**PLANNING COMMISSION AGENDA
THURSDAY, FEBRUARY 14, 2019
7:00 PM**

Subject: **Panda Express – Amend Planned Development and Site Plan Application #19-002–Request to construct an approximate 2,300 square foot Panda Express Restaurant, with one drive-through window, within the Hartland Towne Square development (Outlot #8)** Project site is located north of Highland Road (M-59), south of Hartland Square Drive, and west of Hartland Road (Tax Parcel ID #4708-21-400-074)

SP1.04

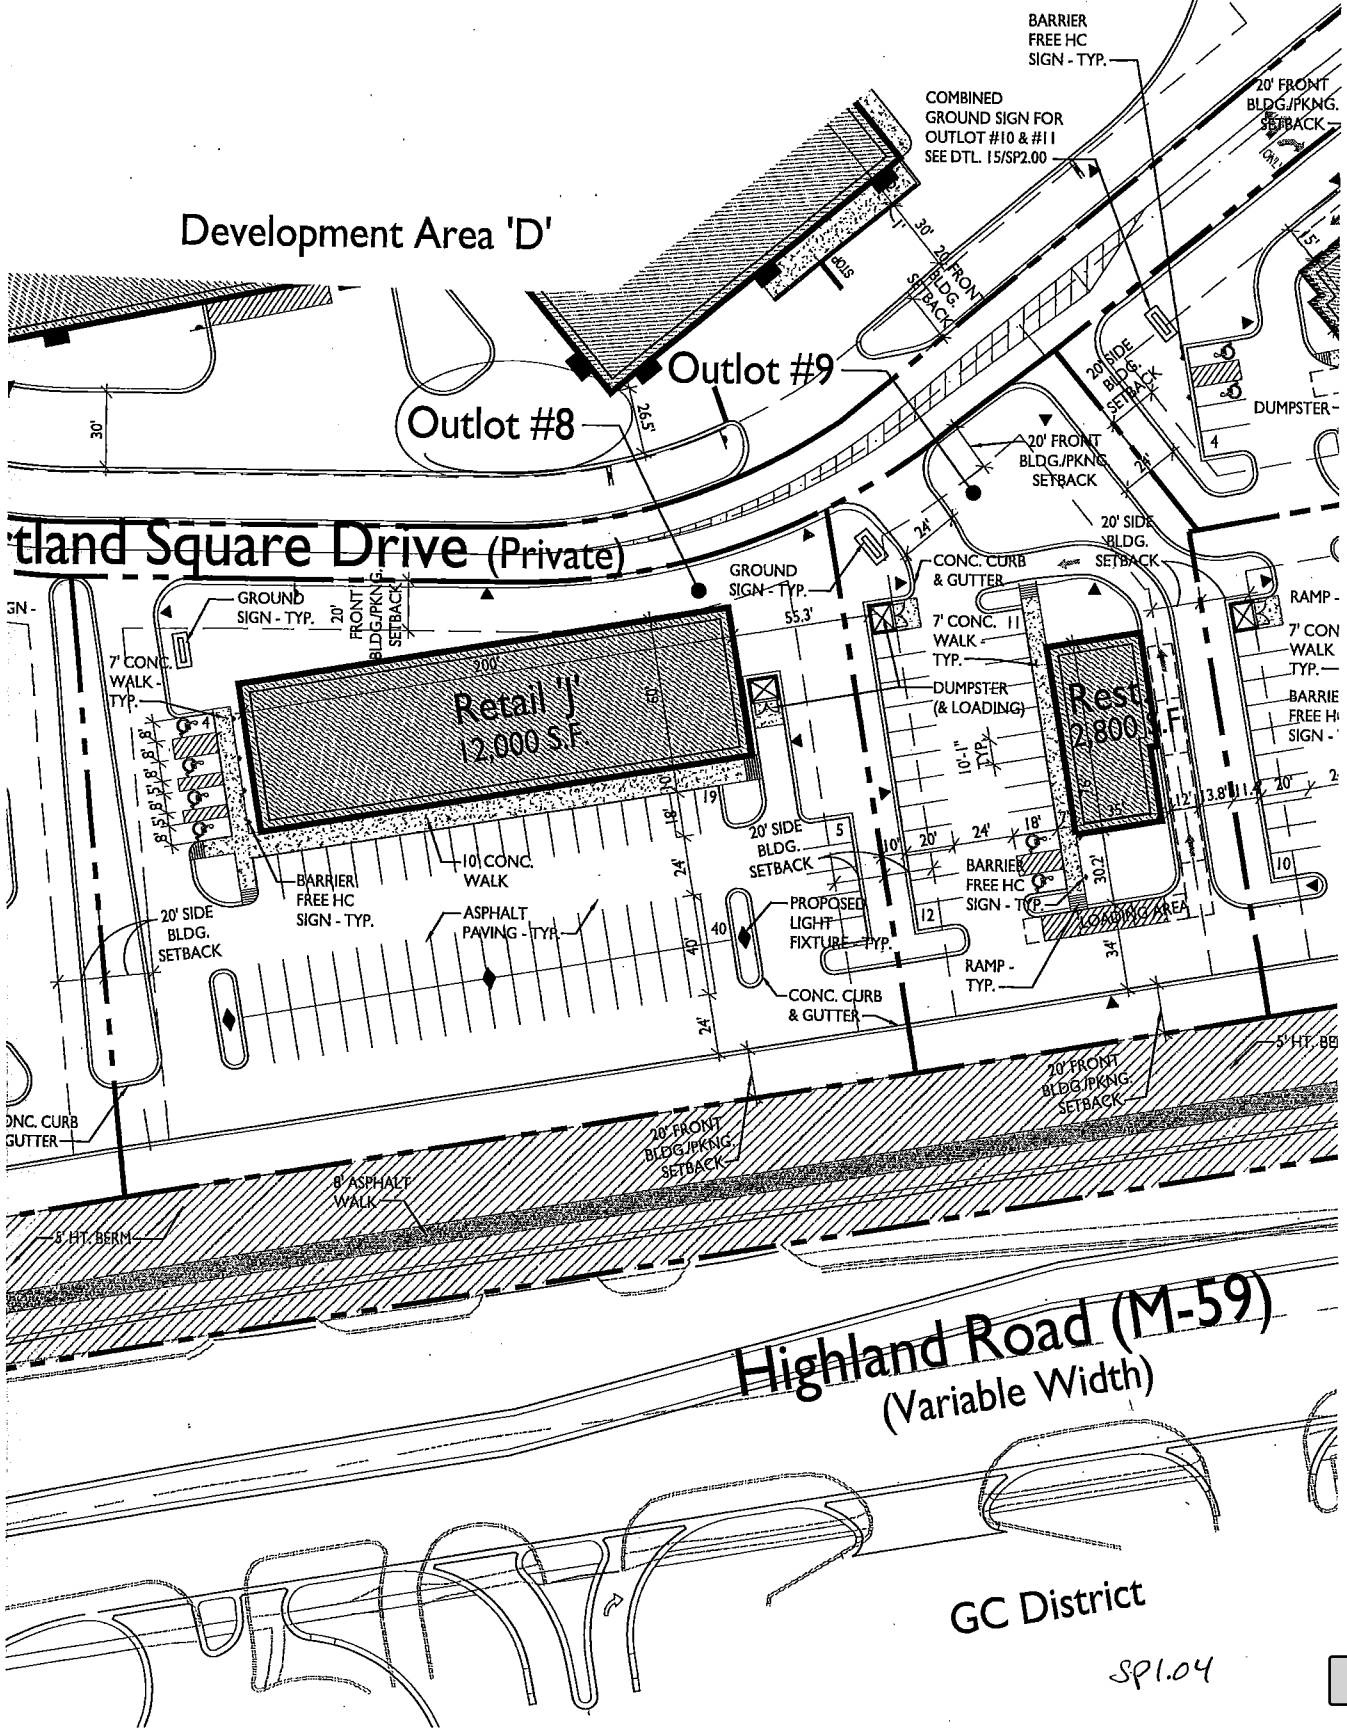
Building Setbacks (Per approved Final Plan - Sheet SP 1.04)

Parking Lot / Driveway / Internal Roads Setbacks (Per Final Plan- Sheet SP 1.04)

Building Height (Per Final Plan- Sheet SP 1.04)

EAST ELEVATION 2
Scale= 1/4" = 1'-0" A-201

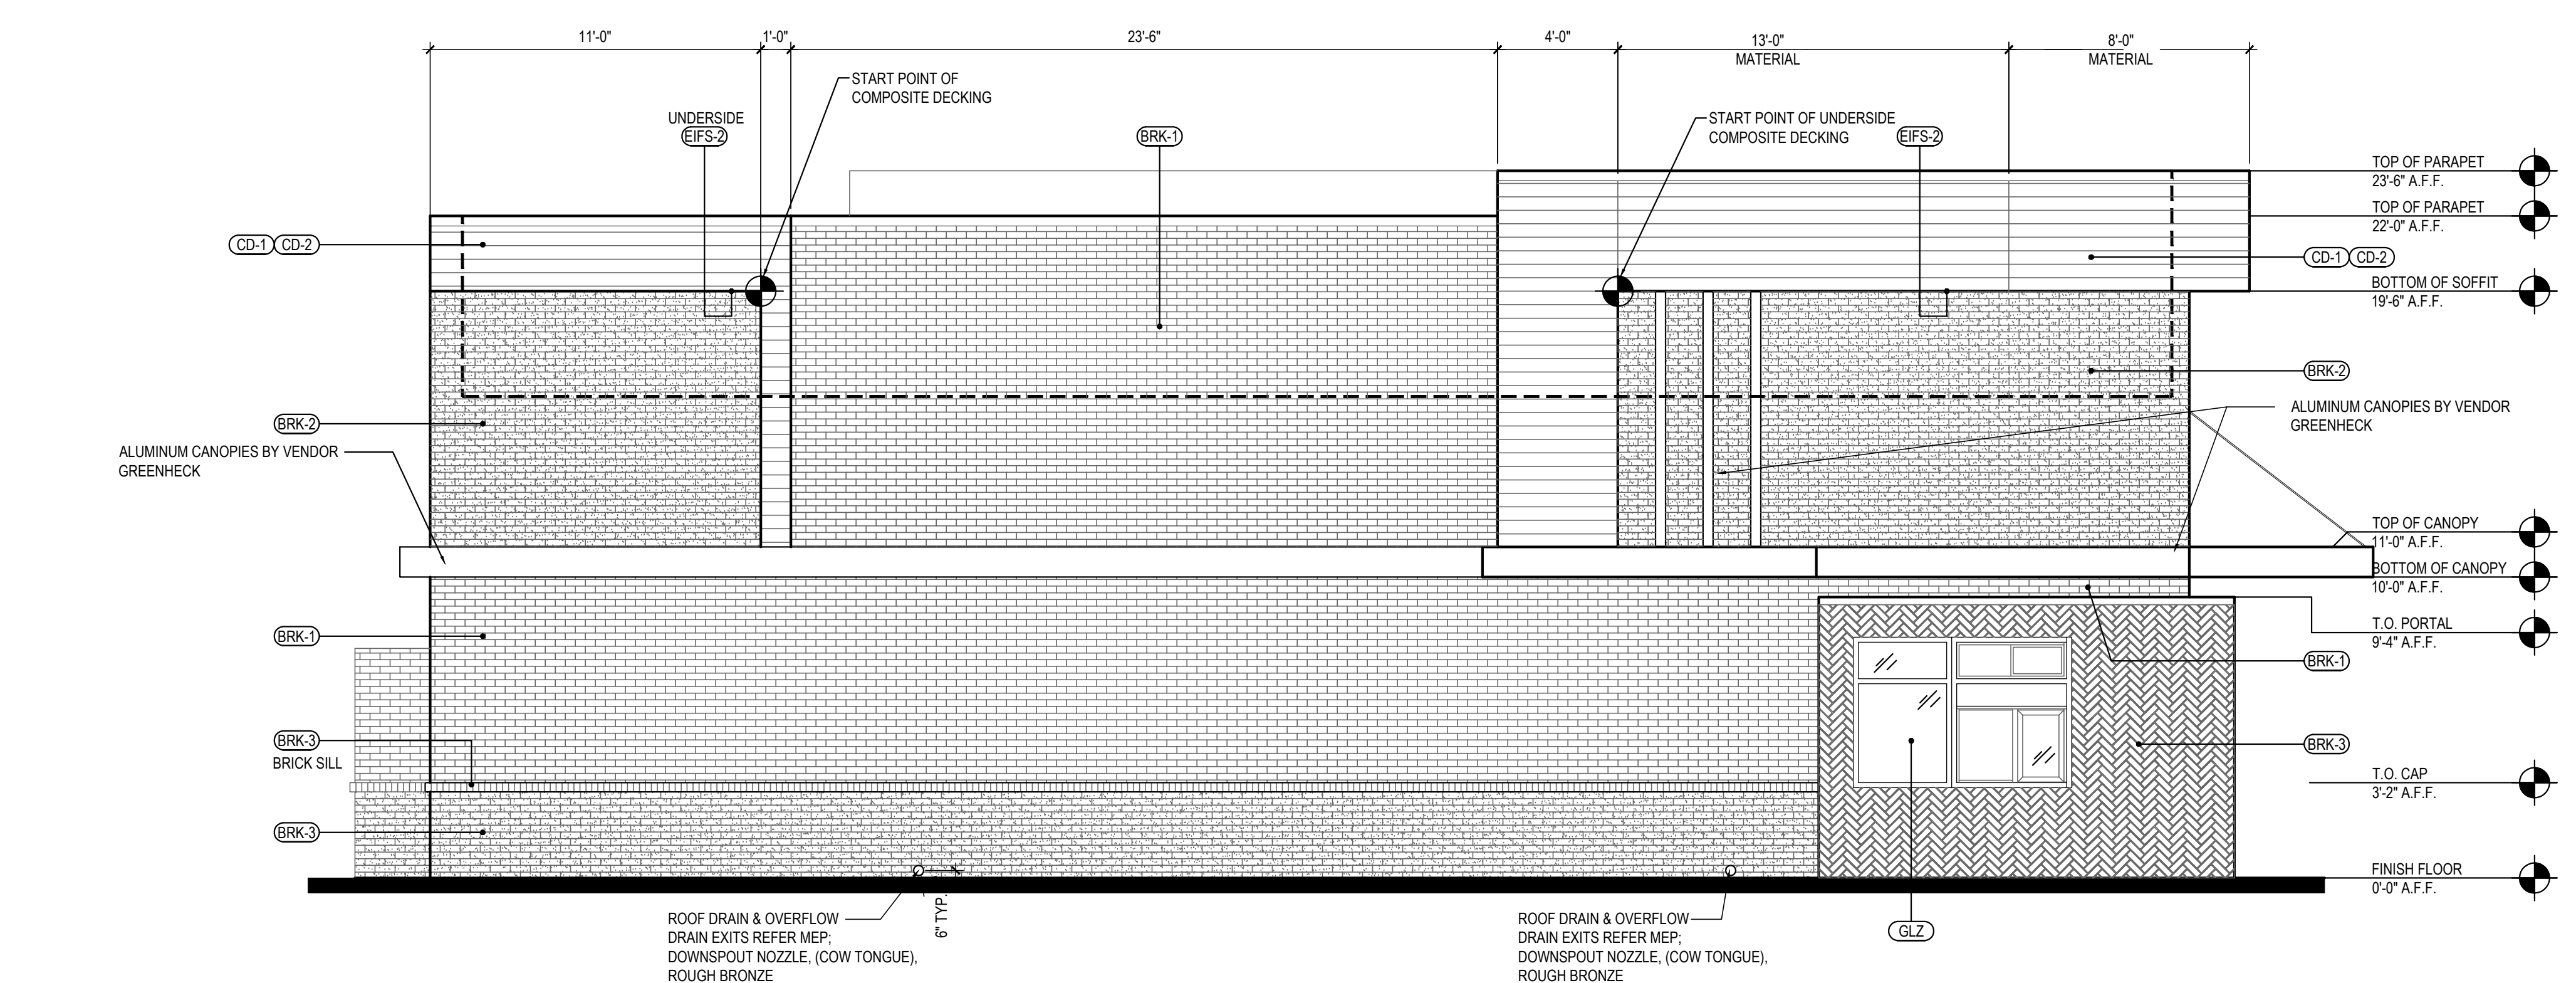
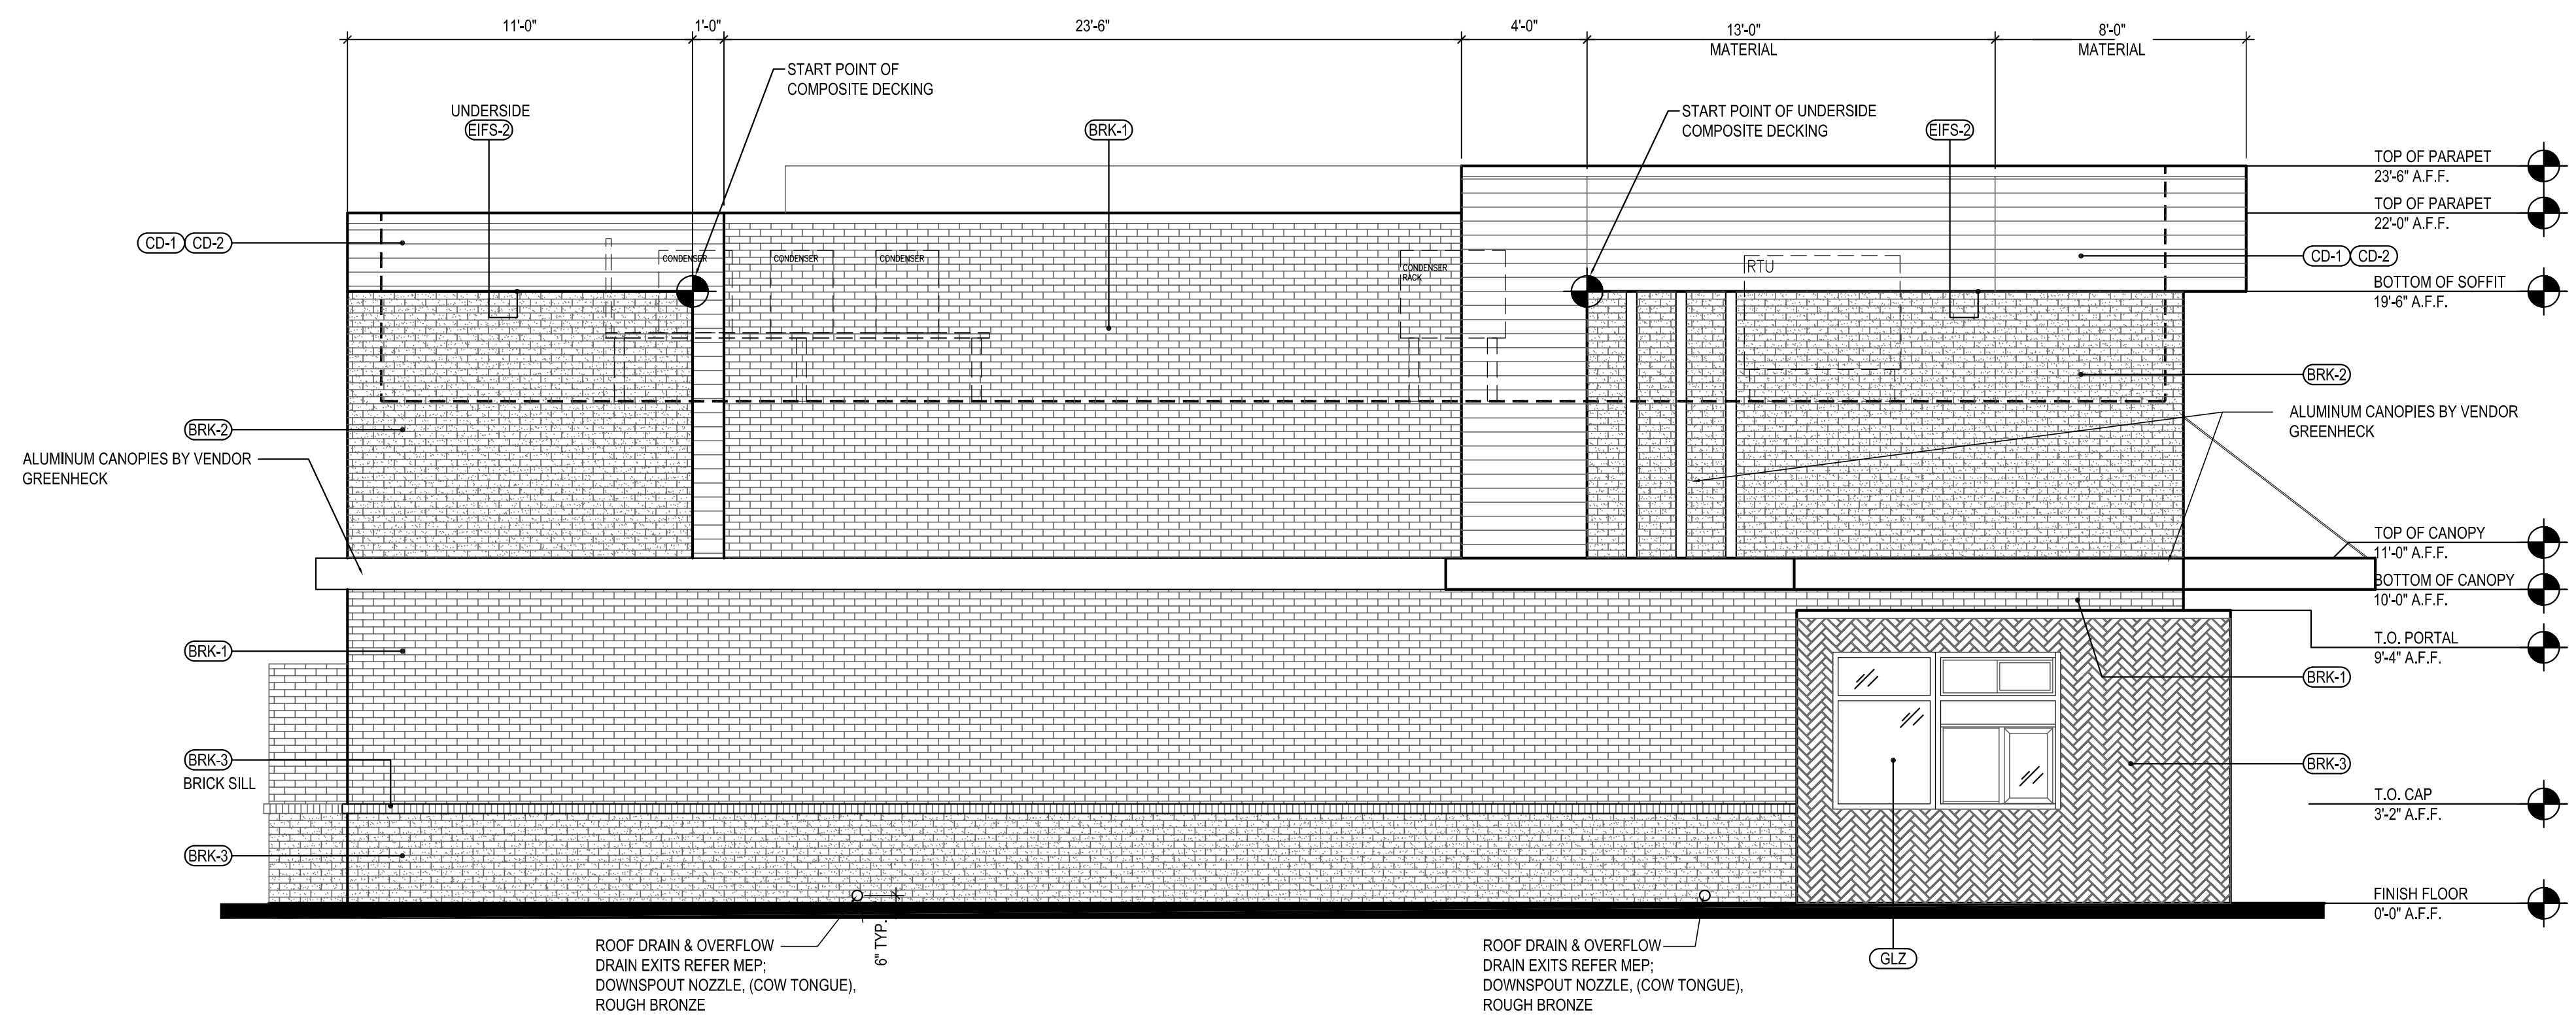
- Roof appurtenances – All rooftop equipment is to be screened behind the proposed parapet walls, per Sheet A-200 and A-201(revised elevations, PDF version only).
- Transformer (north side of building) – screening of a transformer is required. The plan shows two ornamental trees on the north side of the transformer which provides some screening. Screening of the east and north sides of the transformer with landscaping is difficult due to spatial constraints and bike racks (east of transformer).
- Bike Racks – Bike racks are provided north and east of the building and adjacent to parking.
- Ground Sign – A monument sign is not shown on the plans. The Pattern Book provides design standards for a monument sign regarding size, height and type of building
